## **Appendix 'C'**

### **Comments Received**

**Re: Proposed Development Application  
Proposed Official Plan Amendment & New Secondary Plan (DRAFT)  
for Langstaff Gateway, Town of Markham**

**Re: Comments on the Markham Langstaff Master Plan and Proposed Official Plan Amendment and Secondary Plan for the Langstaff area in the Town of Markham - File No. D10-ST-RE - (SRPD.10.031)**

MASTER PLAN

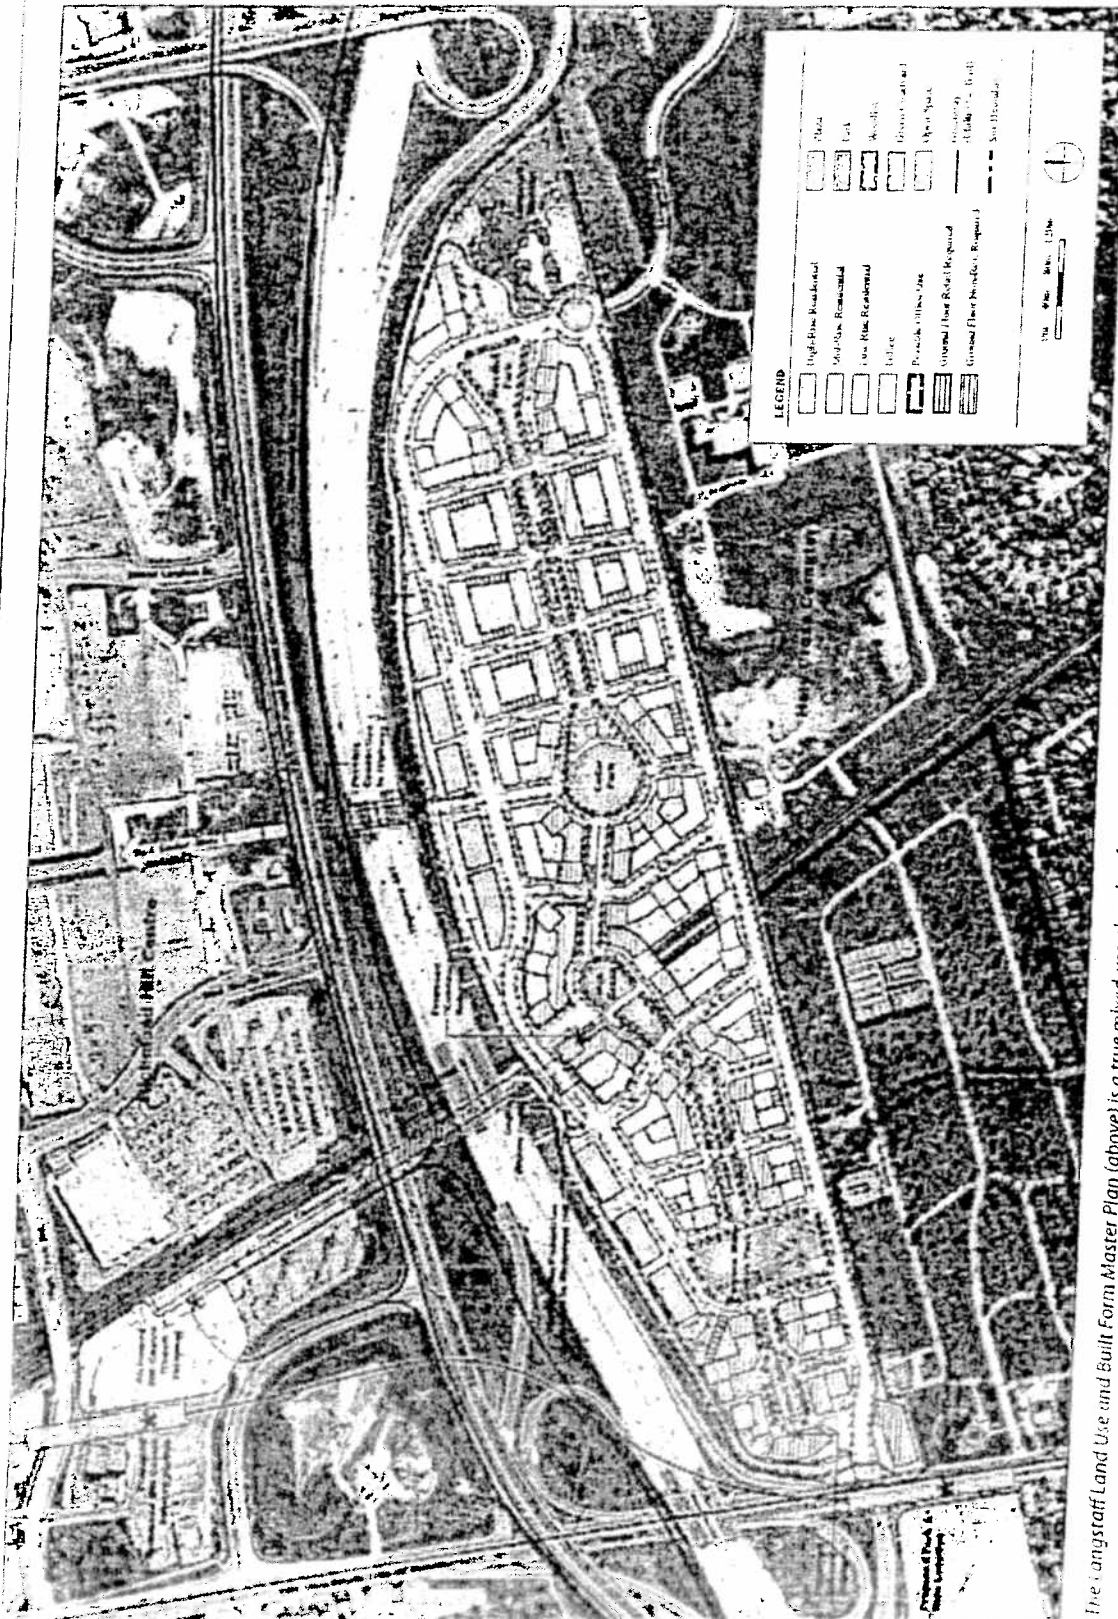
- Town staff are concerned about the density proposed in the Langstaff Plan and the impact of that potential density and traffic on Richmond Hill. At a regional level, the proposed density for the Langstaff site is disproportionate considering the limited connectivity of the site and the lack of direct higher order transit access primarily to the eastern half of the Langstaff area. It is understood that the density provisions identified in the Growth Plan (200 people and jobs/ha) and the Regional Transportation Plan (RTP) (400 people and jobs/ha) are minimum targets to be achieved across the entire UGC. However the density proposed for Langstaff is estimated to be 881 persons and jobs per hectare, a figure that is more than double what is contemplated by the Growth Plan and Metrolinx density targets.

- Approximately half of the Langstaff site is not within walking distance to higher-order transit, particularly the area east of the CN Rail line, but is supported with a connection via a pedestrian concourse into Richmond Hill. In this regard, Richmond Hill staff suggest that a walking distance measured from the entrance to the proposed concourse is not appropriate as transit users would be required to walk an additional 400 metres to reach the planned mobility hub station located in Richmond Hill. The proposed concourse should not be relied upon to justify the level of development proposed for that area of the Langstaff site, as it is not an appropriate walking distance from the actual rapid transit station.

- The Langstaff Plan's greatest allocation of density appears to be around the CN Rail corridor. This density allocation appears contrary to the principles established by the Region that call for concentrating densities at the planned higher order transit facilities and decreasing with distance from those facilities. To conform to these principles, the density shown adjacent to the CN Rail corridor is more appropriate closer to Yonge Street in proximity to the Longbridge subway station area. On this point, Richmond Hill Staff suggest that the Langstaff Plan does not meet the Region's agreed upon principles.

- The circulation of people and movement of goods within the Langstaff site is restricted by the lack of public roads connecting Langstaff to the existing street grid. Due to the constraints of Highway 407 to the north and the Holy Cross cemetery to the south, the Langstaff Plan relies on three mixed-traffic roads for ingress and egress in and out of the site. This is recognized in the Langstaff report which states that: "issues related to infrastructure and circulation in the Langstaff project area are extremely complex and will certainly require much ongoing study in the years to come". While the plan is clear in that it contemplates a large number of car-free households and a high level of transit dependability, the lack of ingress and egress opportunities matched with the planned population and employment not only in Langstaff but also in Richmond Hill could lead to unacceptable traffic conditions throughout the entire UGC and pose significant constraints on the road network already in place, including the road network in Richmond Hill.

- A main component of the road network within the Langstaff area is the proposed Red Cedar Avenue connection under Hwy 407 and Hwy 7 to High Tech Road. This four (4) lane street connection is intended to permit cycling, pedestrian, buses and vehicles. The Langstaff Plan shows this connection as being constructed as part of Phase 1. Further discussions are required between Richmond Hill and Markham on the timing of this road connection. Following the analysis of the transportation study being undertaken by York Region, Richmond Hill Council approval will be needed to approve the Red Cedar Avenue connection prior to the connection being constructed, with an understanding of supporting traffic mitigation measures needed before this road connection is made.
